**EPA Superfund  
Explanation of Significant Differences:**

**COMMENCEMENT BAY, NEAR SHORE/TIDE FLATS  
EPA ID: WAD980726368  
OU 01  
PIERCE COUNTY, WA  
08/03/2000**

**EXPLANATION OF SIGNIFICANT DIFFERENCES  
COMMENCEMENT BAY NEARSHORE/TIDEFLATS SUPERFUND  
SITE**

**August 2000**

Figure 2A  
Thea Foss Waterway Cleanup Area

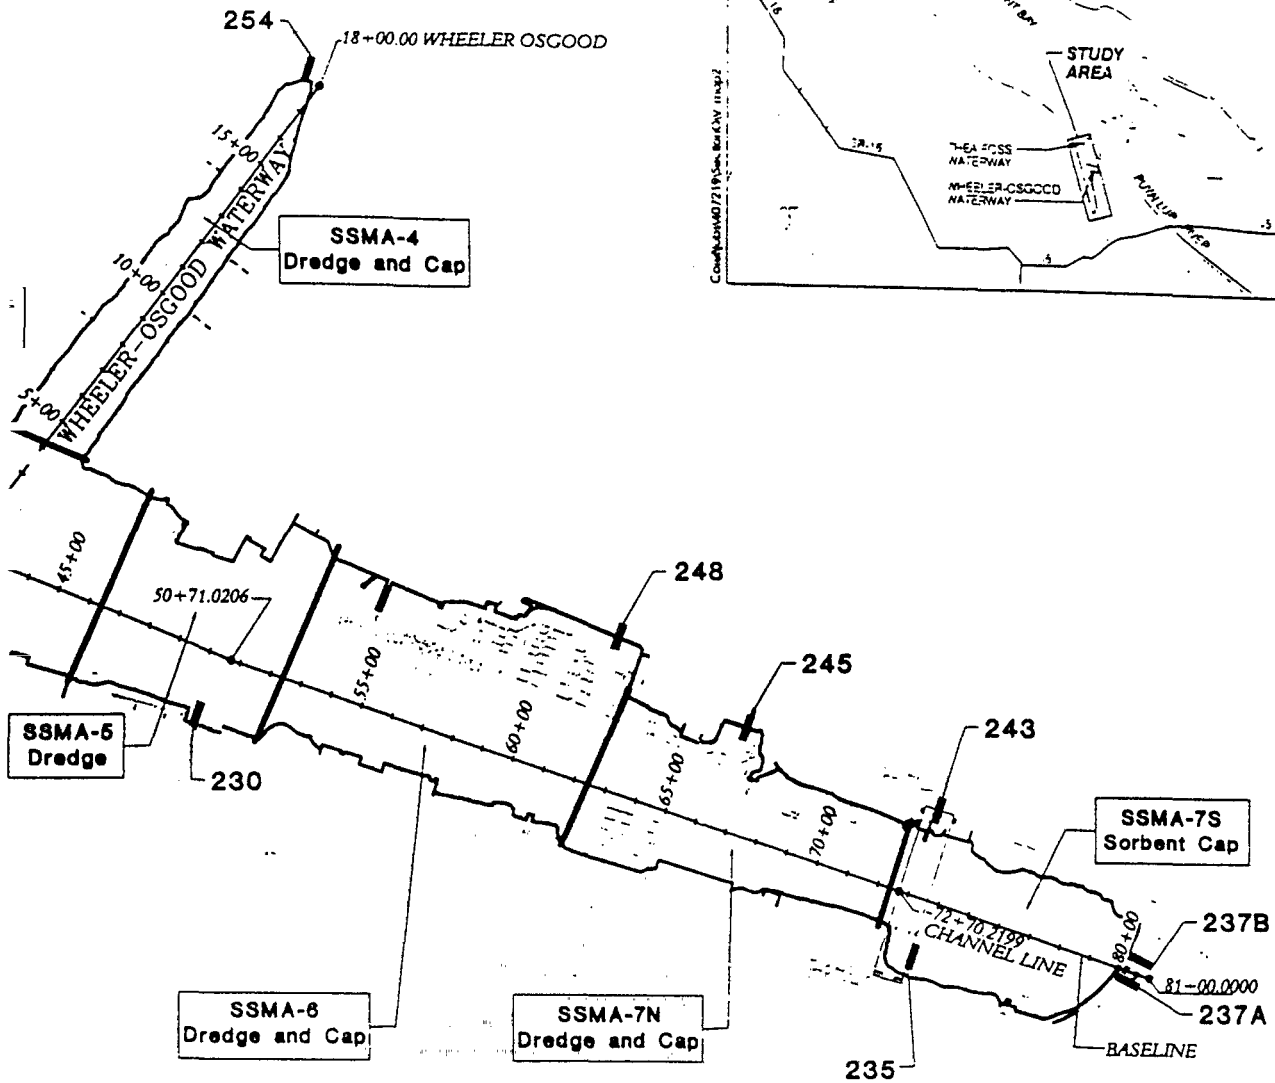
The majority of areas within SSMA 3 have SQO exceedances that require removal and/or capping. SSMA 3 in the navigation channel between the 11th Street Bridge and the 15th Street right of way (ROW) (SSMA 3b1, 3b2, 3b3, 3b4, 3b5a, and 3b5b) will be dredged to a specified elevation of -32 feet MLLW (elevation -30 feet MLLW with a 2-foot over-dredge allowance) to remove all contaminants. Post-dredge samples will be taken to assess chemical concentrations of the dredged surface. If necessary, further dredging and/or some amount of capping may be required. Non-channel areas will undergo a combination of cleanup actions, including no action, natural recovery, capping, and dredging. SSMA 3a1 requires no action based on existing conditions. SSMA 3a2 and 3a3 are suitable for natural recovery. SSMA 3c1 will undergo a combination of cleanup actions including natural recovery, enhanced natural recovery, dredging and capping. SSMA 3c2 and 3c3 are areas suitable for capping.

Chemical exceedances in this segment indicate that active remediation needs to occur in two main areas: SSMA 4a and 4c. These areas will be dredged to remove contaminated sediments. It is expected that all contaminants will be removed. The City's studies suggest that dredging SSMA 4a four feet will remove all contaminants. It is expected that SSMA 4c will be dredged to an elevation of -8 feet MLLW (which includes 1 foot of over dredge) to remove all contaminants. This area will then be capped/backfilled to match the current bathymetry for habitat benefits. Approximately 5,000 cy and 22,100 cy will be dredged from SSMA 4a and 4c, respectively.

**Figure 2C**  
**Head of Thea Foss Waterway**

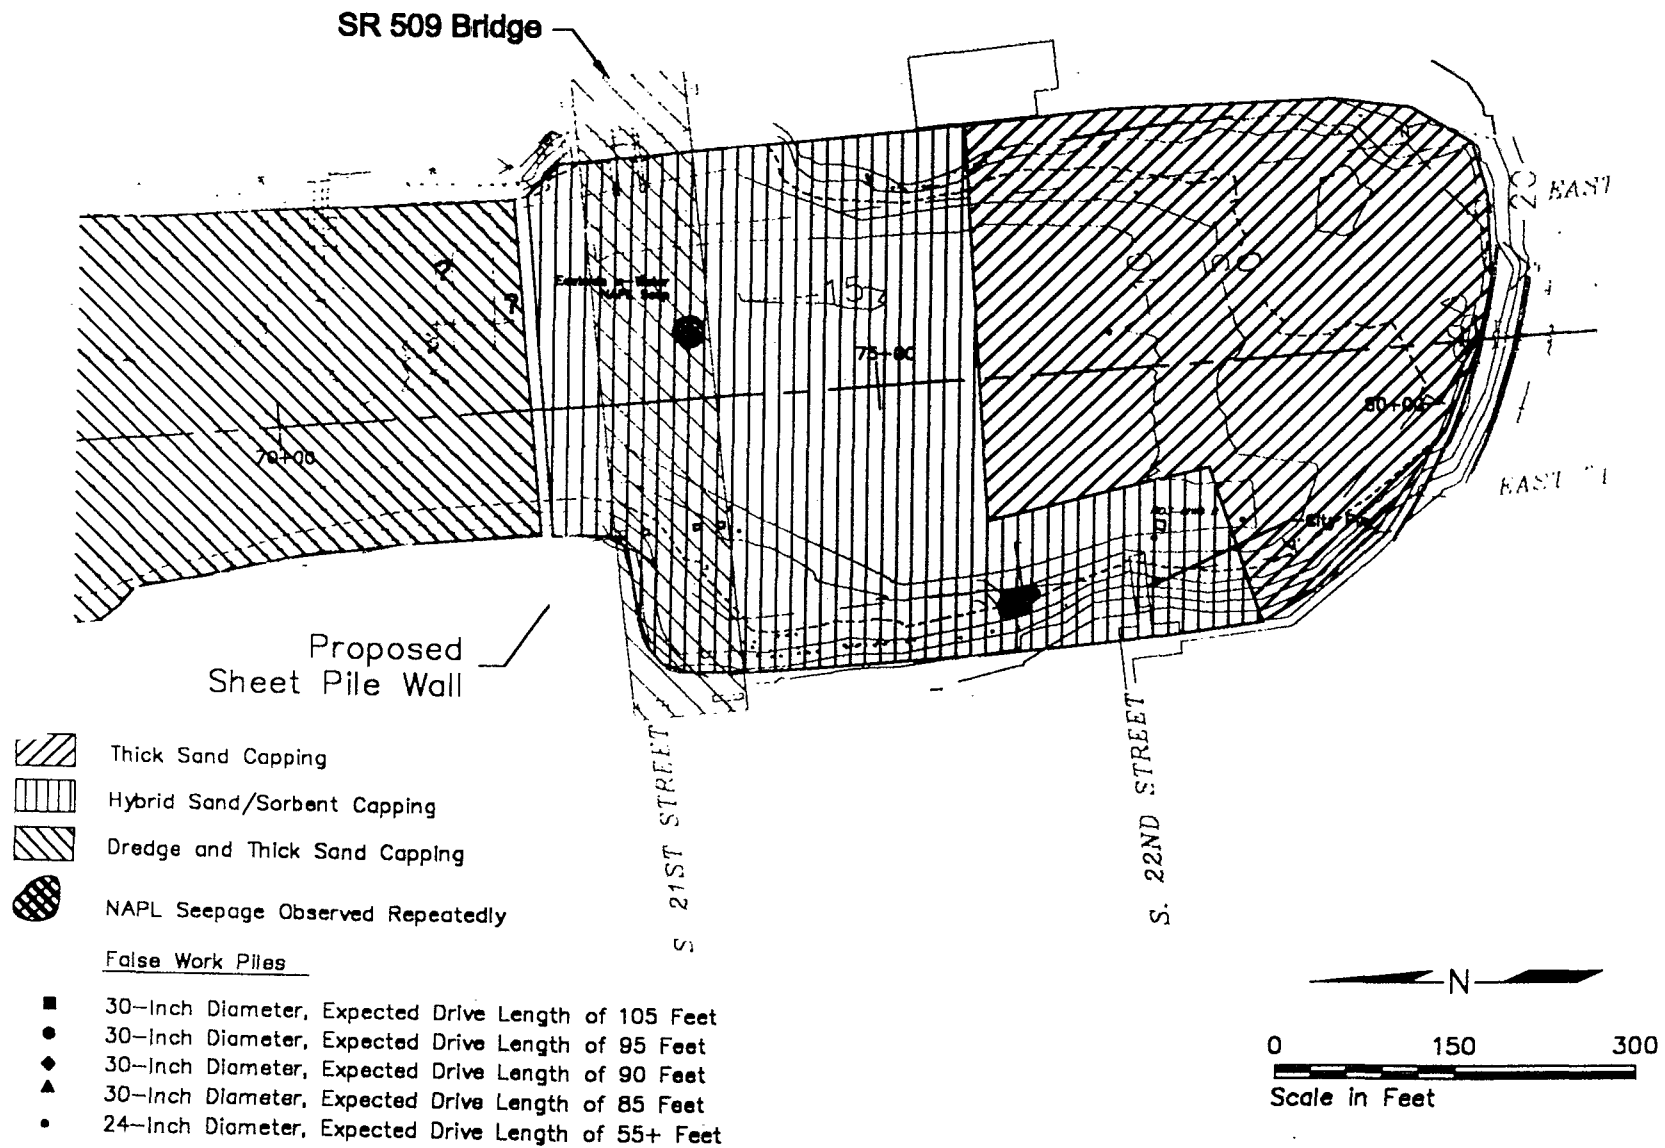
In the “Round 3 Data Evaluation and Pre-Design Evaluation Report, Appendix U,” the City of Tacoma recommended a specific in-water remedial action for the head of the Thea Foss Waterway to address the in-water NAPL contamination and seeps. Based on a subsequent technical memorandum, (Technical Memorandum from Hart Crowser to Mary Henley, City of Tacoma, dated June 14, 2000) the City of Tacoma modified their recommended approach.

The City’s modified approach for remediation is acceptable to EPA. In the design phase and prior to remedial action, however, the following specific performance criteria for source control and the remedy for the head of the waterway must be met to eliminate or reduce the potential for

**Figure 3A**  
**Hylebos Waterway Cleanup Areas**

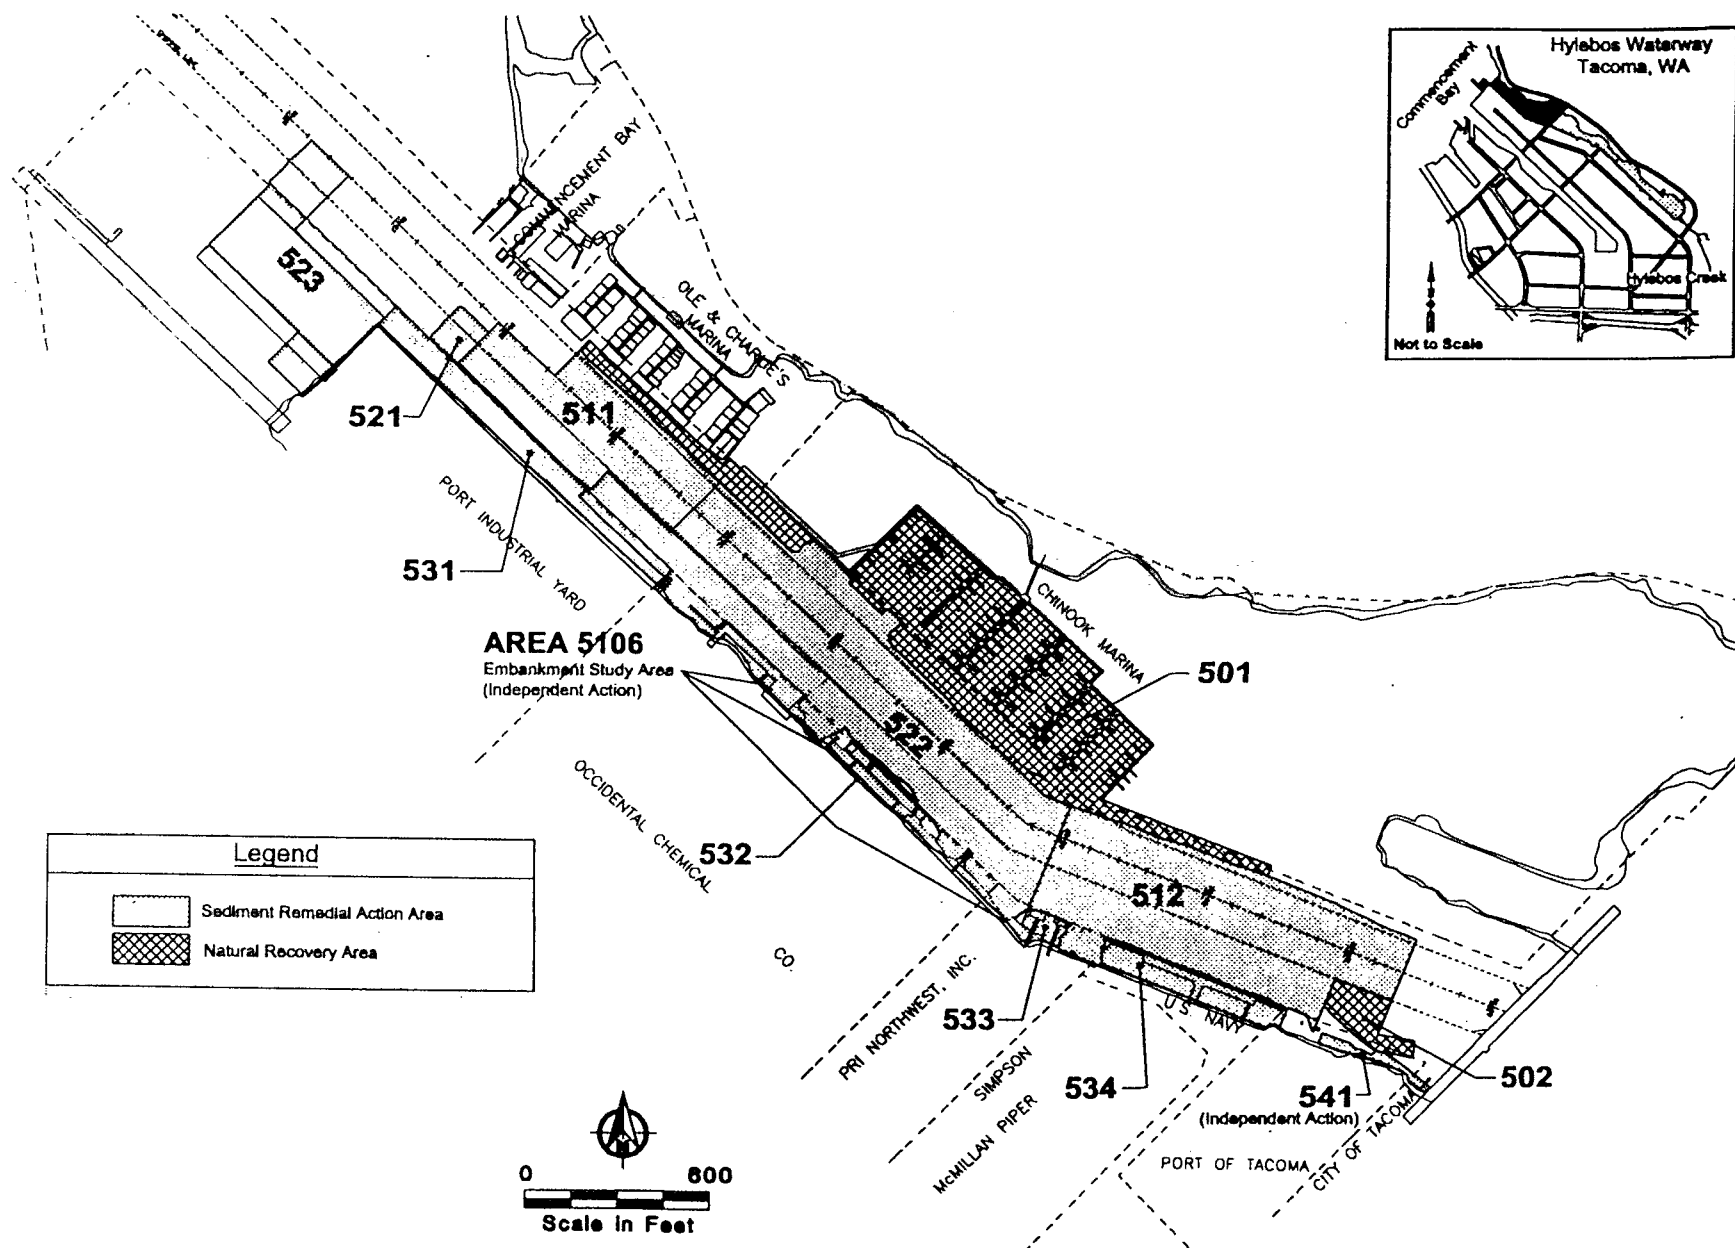
in the Hylebos Waterway, and proposed disposal sites for dredged sediments. The proposed cleanup plan is shown in Figures 3a-c, and is described in more detail in the report.

As shown in Figure 3a, most of the waterway north of the 11<sup>th</sup> Street Bridge is to be dredged under the cleanup plan. The area in front of Ole and Charlie's Marina (Sediment Management Area, "SMA" 511), within and in front of the Chinook Marina (SMA 501), and a small area near the 11<sup>th</sup> Street Bridge (SMA 502) contain only low-level contamination and will be monitored as natural recovery areas.

Figure 3C  
Hylebos Waterway Cleanup Areas

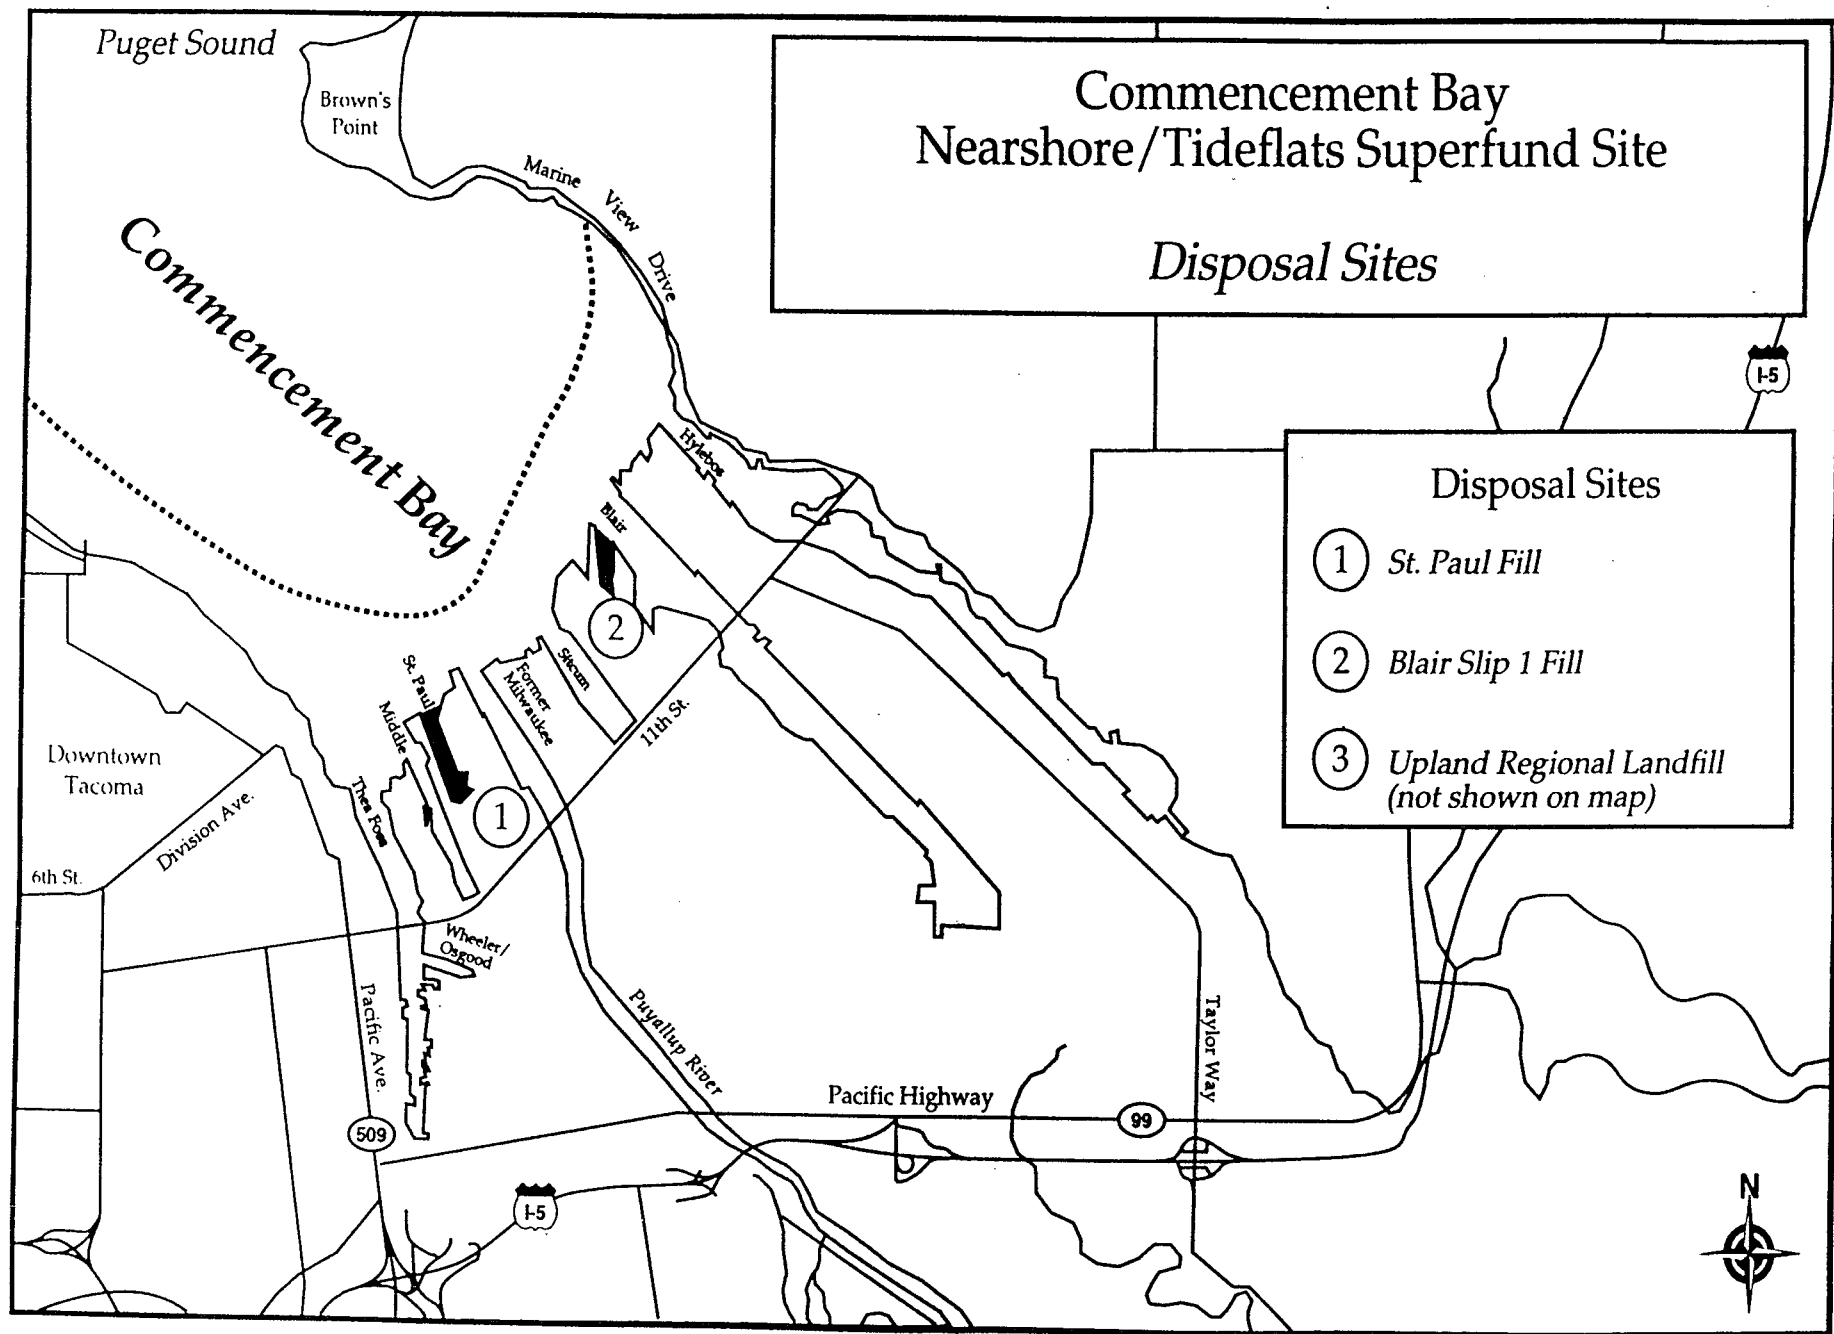
Some intertidal cleanup actions have been addressed by individual property owners working with Ecology. Those intertidal cleanups where EPA has approved the final cleanup will not require remediation as part of the overall waterway cleanup. EPA will, however, determine whether long-term monitoring is needed at these properties as part of the waterway design process. To date, EPA has approved the intertidal cleanups at SMA 232 at General Metals of Tacoma and SMA 241 at the former USG Interiors facility (see Figure 3-c).
